INL Assessment of PNNL Water Conservation Study for the ATR Complex

INL/EXT-13-29045

August 2013

This report documents an assessment of water conservation measures proposed for the Idaho National Laboratory's Advance Test Reactor Complex. Four of these measures were identified by Pacific Northwest National Laboratory in April 2012 and evaluated for potential water savings, energy savings, and implementation costs. Six additional measures were identified and evaluated by the Idaho National Laboratory. The original water assessment conducted by Pacific Northwest National Laboratory was sponsored by the U.S. Department of Energy Sustainability Performance Office to support implementation of the Department of Energy's Strategic Sustainability Performance Plan.

Figure 1. Secondary/UCW system flow diagram.

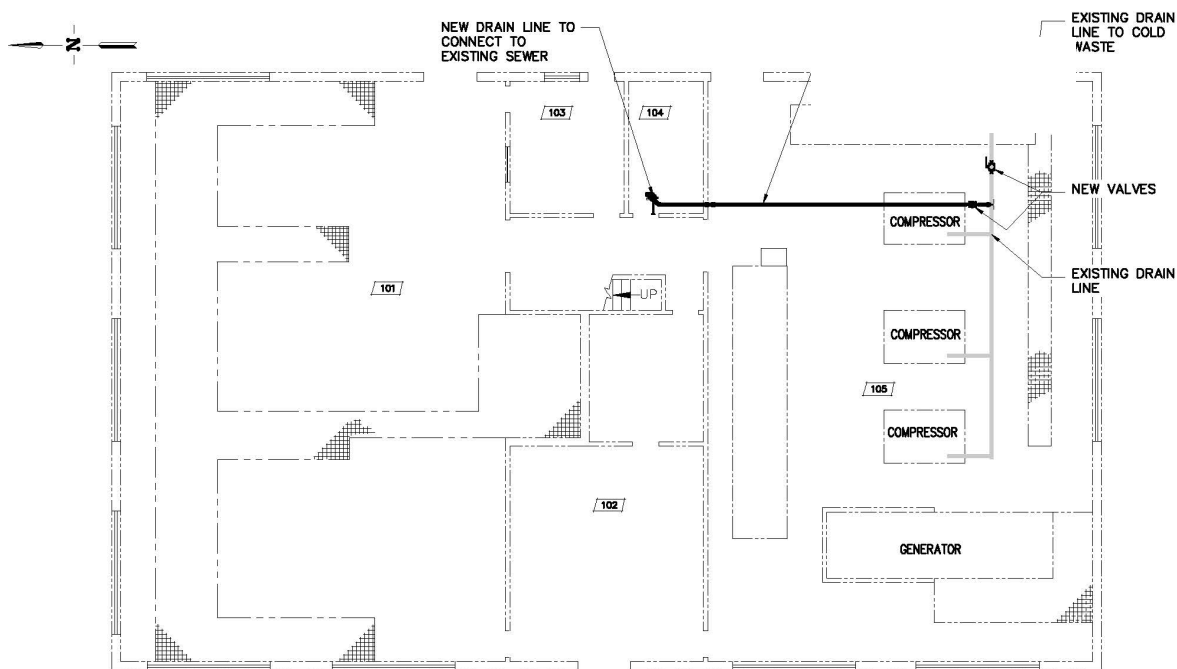
There are several issues associated with moving to an automated system and changing the water chemistry control system. First, the PNNL study did not include the full scope of work necessary to implement an automated system. The automated system would require engineering design, configuration control work, piping modifications, software modifications, procedure updates, and training for all operators and other affected personnel.

Second, chemistry control is the key to continuous operation of the test reactor. The ATR secondary cooling system is using the original, 50-year-old piping installed in the mid to late 1960s. The bulk of the components in the system are original to the plant, including the primary heat exchangers. Age and use have naturally deteriorated many of these older components, particularly with regard to corrosion. Changes to the chemistry control, if not properly analyzed and studied, could have detrimental effects on the components in the system, resulting in extended down time and costly repairs. In this time of reduced funding, it would be difficult to obtain the necessary money to replace the heat exchangers or other large components in the secondary cooling system. The current chemistry control process is known and has proven to maintain low corrosion rates in the system. Any perturbations to the system would need to be very carefully studied and analyzed.

Any changes to the chemistry and control of the ATR secondary cooling system must be very carefully considered. The PNNL study does not explore the full implications of the proposed changes, and only focuses on the potential water savings, giving no consideration to the full impact of the change. Further study is necessary to determine feasibility of the addition of an automated blowdown control.

Figure 2. Hypochlorous acid (undissociated) in aqueous solutions.^c

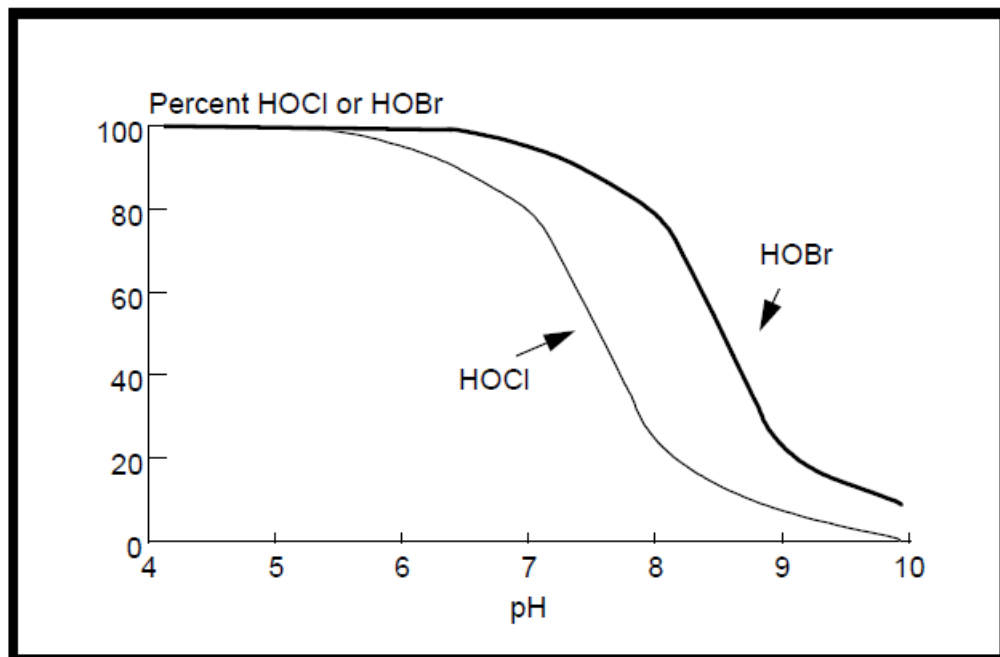
Changing the corrosion control regimen could negatively impact the efficacy of the biological treatment program. PNNL's recommended changes in chemistry would force a substantial increase in pH. The chemicals currently added to the SCS to eliminate biological growth are WRICO BGA, an algaecide, and sodium hypochlorite. Ashland Water Technologies, the supplier for the WRICO BGA, reported that raising pH would have little impact on WRICO BGA's performance.^b However, the efficacy of sodium hypochlorite changes substantially with pH higher than 7.5. Sodium hypochlorite added to pH neutral water forms hypochlorous acid, the active toxicant for biological growth. Sodium hypochlorite works well in systems with near neutral pH. However, raising the pH drives the ionization of the hypochlorous acid to form hypochlorite ions, which are considerably less effective as biological agents.^c Figure 2 shows the effects of changing pH on the percentage of hypochlorous acid in the system. Adopting a corrosion control system that requires pH above the present range would force a change in the biological treatment program, adding substantially to the cost of the change in corrosion control.

The greatest concern of increasing COCs is the additional risk of forming scale in the SCS, especially on the primary heat exchanger tubes. High power runs will be much more frequent over the next several years. Loss of heat rejection capability would jeopardize the reactor plant's ability to perform those runs.

A second concern, previously described, is the possibility of having to adopt a new method of biological control if the corrosion control process requires a higher pH band than the current process. Costs of implementing the chemistry package would increase substantially if a change in biological treatment is required.

Figure 3. ATR auxiliary cooling diagram showing the current routing in black and the proposed routing in red.

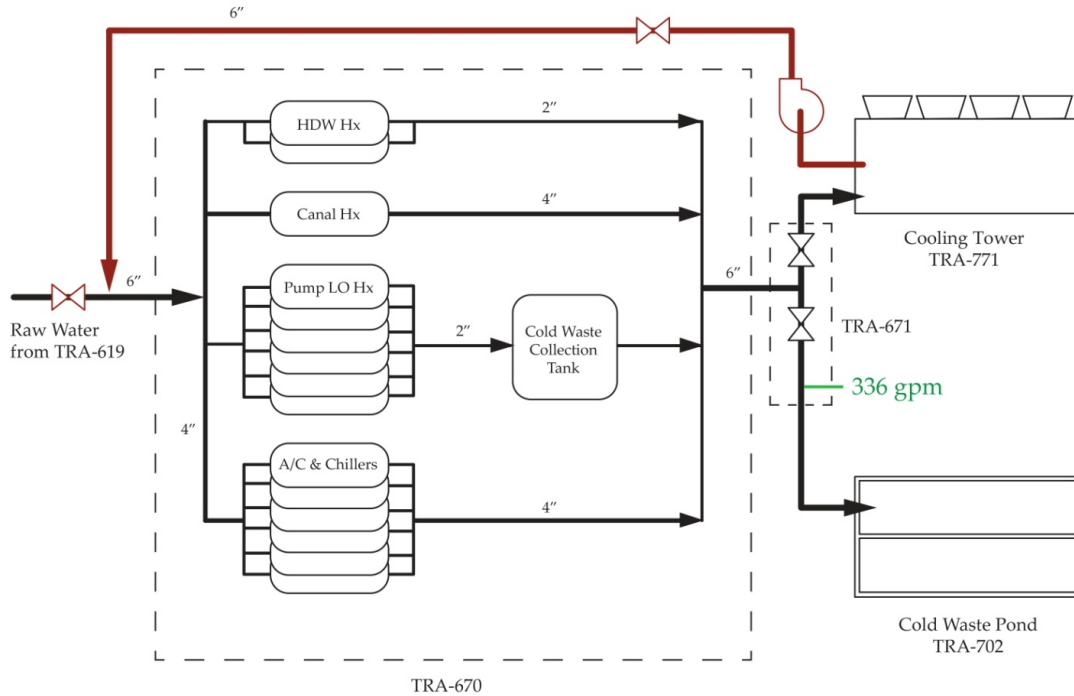
The PNNL report proposes a route for the auxiliary loop that would start at the TRA-670 cooling tower basin and connect to the 6-in. raw water supply line that enters TRA-670 through the east wall of the first basement. The recommendation would require installation of a pump, pump controls, valves, and underground piping. Figure 4 shows there are significant underground utilities along the proposed route that would complicate the installation of the auxiliary loop piping and isolation valves. A suitable location for the pump and controls would also be required.

Implementing the PNNL recommendation could potentially create a cross connection with the backup ATR Complex potable water system. A cross connection with potable water would require the installation to meet American Water Works Association (AWWA), American National Standards Institute (ANSI)/National Science Foundation (NSF) standards and Idaho Administrative Procedures Act (IDAPA) 58.01.08, "Idaho Rules for Public Drinking Water Systems. A detailed review of these requirements will be performed if this option is considered.

It is the INL's recommendation not to implement the PNNL recommendation to install a new system that will pump SCS water from the cooling tower basin during ATR outages into the 6-in. raw water supply line just before it enters TRA-670. The inadequacy of SCS water as a cooling medium in the tube side of smaller heat exchangers, the high-installation costs, the additional maintenance costs, and operational burdens associated with a system of this type would provide little or no benefit to the program.

Figure 6. ATR air compressor cooling water diagram.

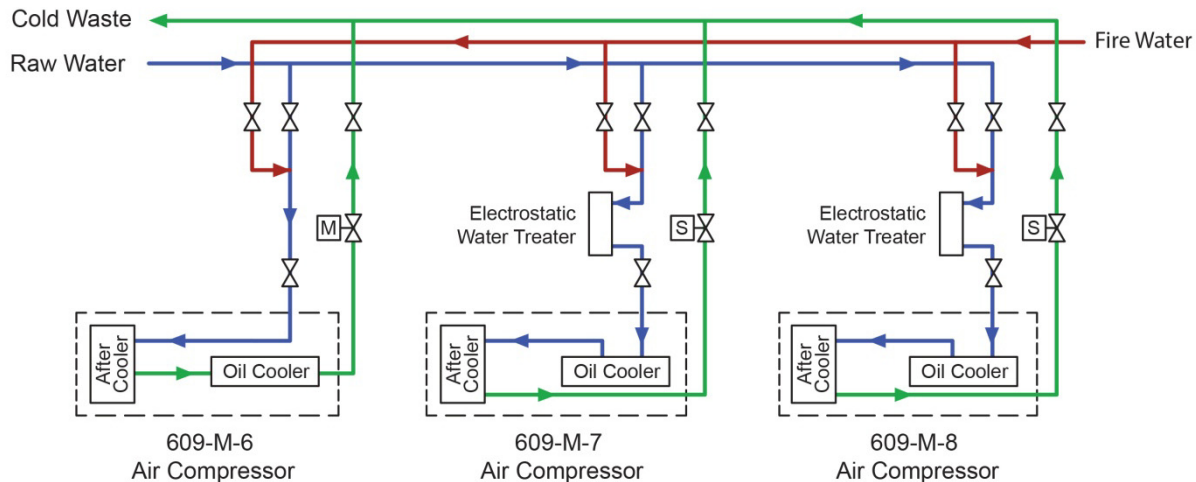
PNNL noted that the annual flow of cooling water through the air compressor heat exchangers was approximately 45 M gallons of non-potable water, based on a 24 hour/7 day per week flow regardless of cooling demand. PNNL recommended installing a skid-mounted closed loop dry-fluid cooling system to replace the once-through cooling water system that is presently being used.

Providing redundancy in the compressed air system is very important and must be considered as part of this proposed modification. A constant reliable supply of clean compressed air to TRA-670 and supporting facilities is critical to the operation of the ATR. Therefore, redundancy was designed into the system. For example, all three compressors can run on commercial electrical power with one of the compressors connected to the backup diesel generator. Also, there are redundant inlet filters, air dryers, outlet filters, and air receiver tanks, along with independent distribution lines, to ensure uninterrupted compressed air service to ATR Complex. As mentioned above, the primary cooling water also has a backup in the form of fire water. There is also a portable, diesel powered air compressor located outside to the south of the building as a standby to the two standby compressors. To ensure redundancy in the compressed air system, two separate standalone dry-fluid cooling units should be installed if this project were to be implemented. The duplication of equipment is required to maintain system reliability while providing flexibility during maintenance periods.

The dry-air cooling systems would probably need to be installed outside due to the limited floor space inside building TRA-609. This would significantly increase the installation costs, operational costs, maintenance costs, increase reliability risk, and add new personnel safety hazards during inclement weather.

The PNNL study did not include the full scope of work necessary to install, maintain, and operate a dry-fluid cooling system for the ATR Complex Compressed Air system. Any new system would require design engineering, configuration control work, compressor heat exchanger modifications, piping modifications, electrical modifications, procedure revisions, and training for all the operators and other affected personnel. It is assumed that PNNL did not consider the redundancy requirement, therefore estimated installation of only one dry-fluid system. The PNNL study identified the estimated total installed cost to be \$67,300 with an annual energy cost savings of \$5,400 per year. A more comprehensive installation cost estimate would likely be significantly higher. The additional maintenance cost associated with the new equipment (dry fluid cooling systems, heat exchangers, electrical switchgear, pressure and flow gauges, cooling fans, pumps, etc.) would significantly increase the payback period.

It is the INL's recommendation not to implement the proposed measure to install a dry-fluid cooling system for the ATR Complex air compressors. The high initial installation costs, the additional maintenance costs, the added reliability risk with a system of this type, (i.e., higher probability failure rate due to the additional pumps, control valves, fans, etc., versus the very simple cooling system that is presently being used), the additional operational burdens and the problems that installing the new cooling system outside creates would provide little or no benefit to the program.

Figure 21. Model predicted sulfate concentration as a function of time at the Well USGS-065 location for the three scenarios examined.

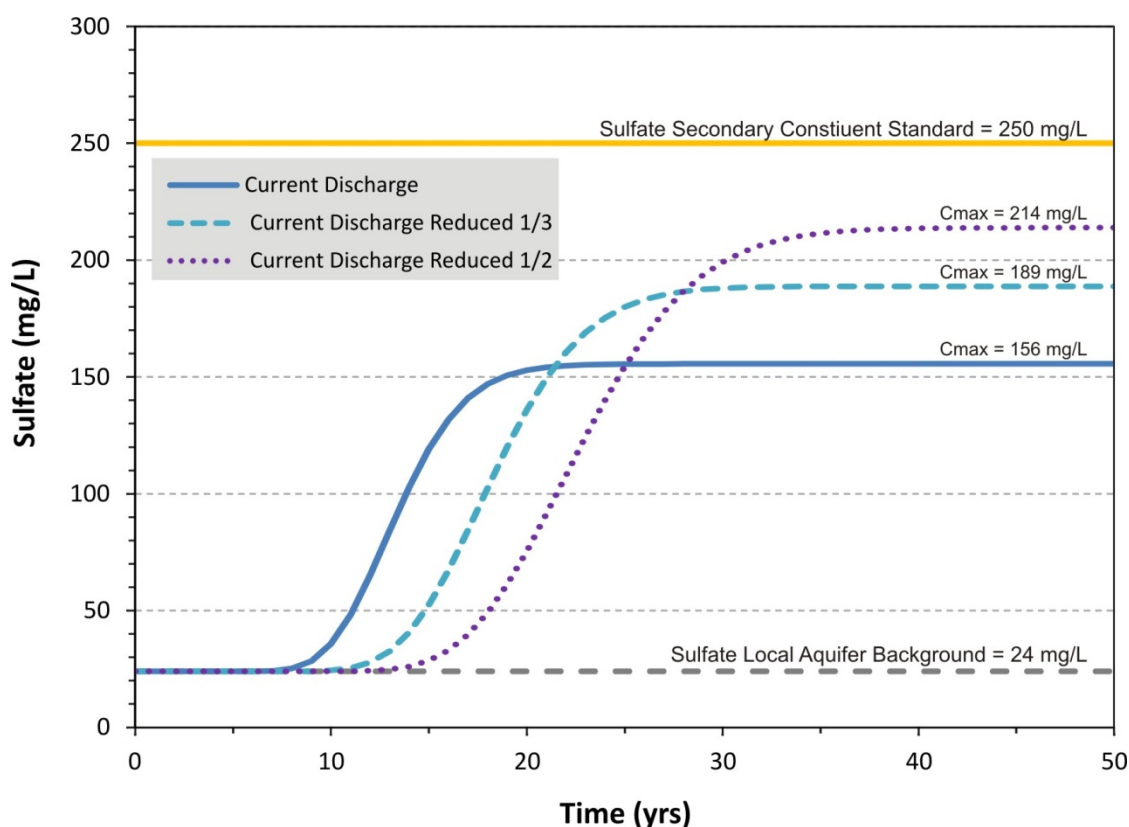
Sulfate concentrations as a function of time are presented in Figure 21 for all three cases examined: (1) current discharge, (2) 1/3 reduction in current discharge by reducing clean water, and (3) 1/2 reduction in current discharge by reducing clean water. The aquifer background concentration of 24 mg/L was added to all model predicted concentrations since the model assumes a clean aquifer with respect to sulfate. For the current discharge case where the water volumes and mass loading rates are based on current values, the maximum sulfate concentration at Well USGS-065 is predicted to be 156 mg/L. This is slightly less than the average concentration of 160 mg/L (see Table 2). The fact that the predicted concentrations match the measured concentrations reasonable well provides confidence that the model is appropriate.

The results indicate that for the case where the current discharge is reduced by 1/3, the maximum predicted sulfate concentration is 189 mg/L. Although the effluent concentration for this case would increase 44%, the maximum predicted aquifer concentration increased only 21% over the current discharge case. For the final case where the current discharge is reduced by 1/2, the maximum predicted sulfate concentration is 214 mg/L. Although the effluent concentration for this case would increase 89%, the maximum predicted aquifer concentration increased only 37% over the current discharge case.

INL recommends consideration of long-term water conservation measures that divert “clean” wastewater from the CWP to the sewage lagoon and any other water conservation measures around the ATR Complex as funding and project prioritization allow. Even though the sulfate SCS are not exceeded, the Idaho IWRP requires compliance with the Idaho Groundwater Quality Standards. Thus, modifications that are projected to further degrade groundwater quality should be reviewed by IDEQ prior to implementation.

Figure 26. ATR Complex plan view showing areas considered for xeriscaping.

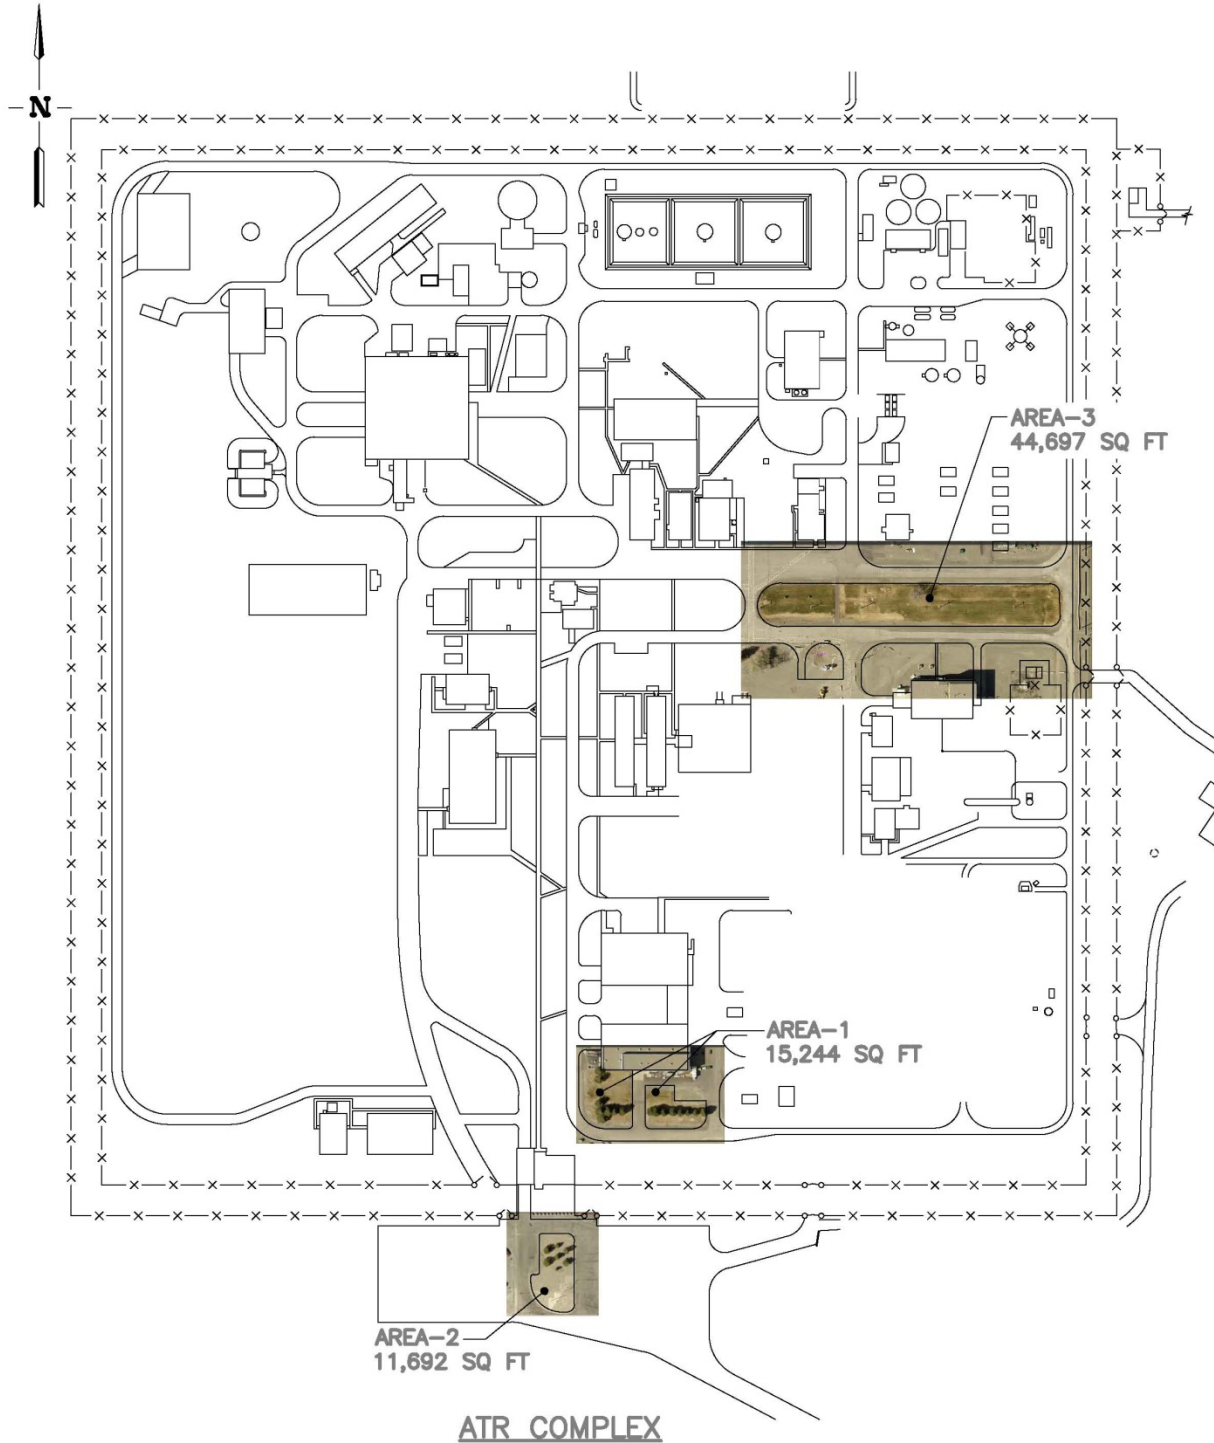
Based on water meter readings on the irrigation system, the current ATR Complex water consumption is 14.2 M gpy for 9.2 acres. Area 2 in Figure 26 does not have any grass; therefore, it is not sprinkled. That area does consume water for the trees planted there. It is assumed that the net reduction of water for this area will be zero. Water reduction will occur in Areas 1 and 3. The total size for the two areas is 1.38 acres. It is estimated that 2.13 M gpy would be reduced by eliminating sprinklers. However, there are 16 trees located in the two areas that require watering. Based on each tree requiring 15 gallons of water per day during the 5 month watering season, it is estimated that 36,000 gpy is required to water trees. Thus, the resulting water savings will be 2.1 M gallons yearly. With an energy cost of \$0.0007 per gallon, it is estimated that \$1,466 per year will be saved.

As INL moves toward more water conscious operations, this option provides water savings and the opportunity to change an ingrained culture. Once safety aspects are approved and funding obtained, this option should be fully implanted as a test case for other areas at the ATR Complex and throughout the INL Site.
